Service Bulletin

American Honda Motor Co., Inc.

2001-2003 GL1800/A ECM Replacement/Cooling System Product Improvement Campaign

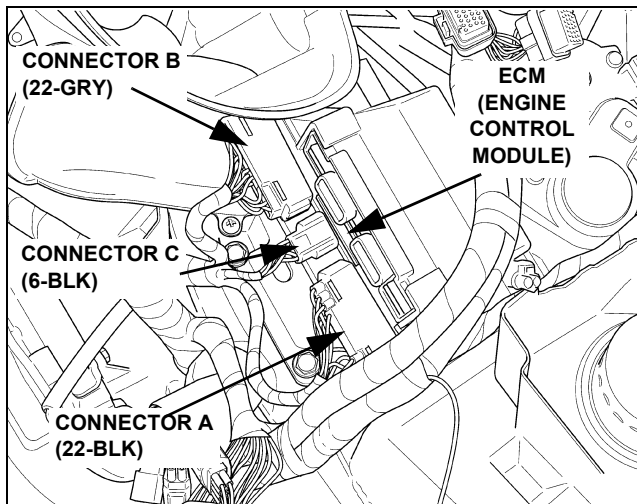
1. Remove the top shelter (See Service Manual, page 2-10).
2. Remove connectors A and B from the cruise/reverse control module. Remove the cruise/reverse control module.

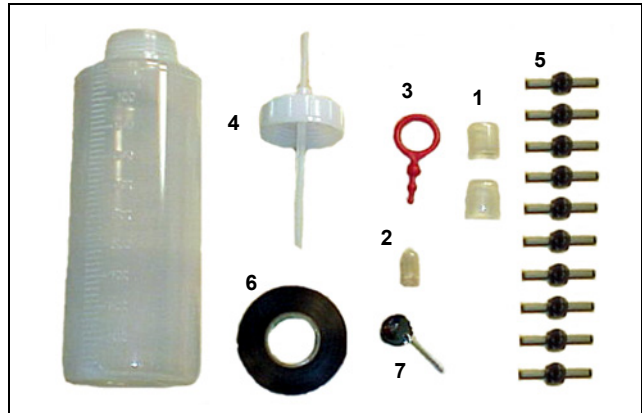
3. Disconnect connectors A, B, and C from the Engine control module. Remove the ECM.

4. Install the new ECM, then reinstall the cruise/reverse control module in the reverse order of removal.

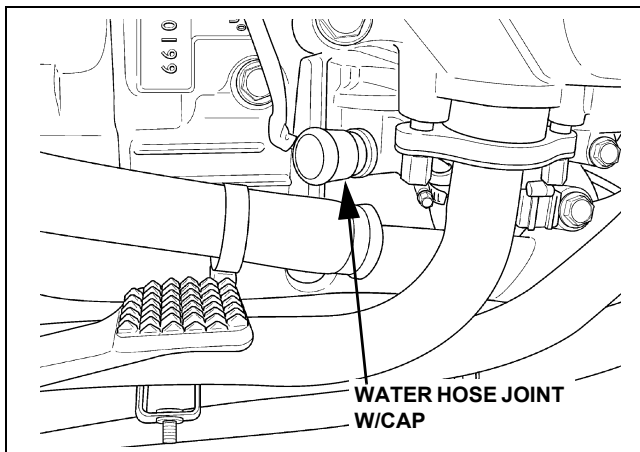
3. Remove and suspend the evaporative canister. (See S/M, 5-72) It is not necessary to disconnect the hoses.
4. Remove the right cylinder coolant hose from the drain joint. Allow the coolant to drain completely and discard it in an appropriate manner. Use caution to avoid being burned by hot coolant. Plug the hose and cap the joint.

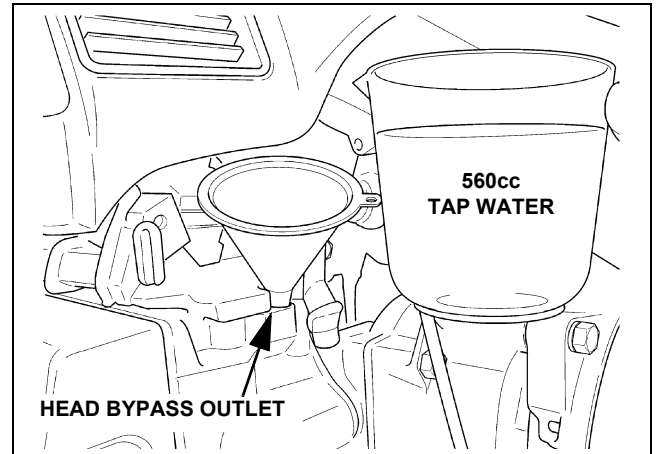
9. Insert the feed hose (or a funnel) approximately 5mm into the head bypass outlet and carefully pour in the water:

- If less than 560cc of water can be added before it overflows, you MUST replace the cylinder head. Refer to the **Cylinder Head Set Replacement** section below.
- If 560cc of water can be added without overflowing, the cylinder head is OK.
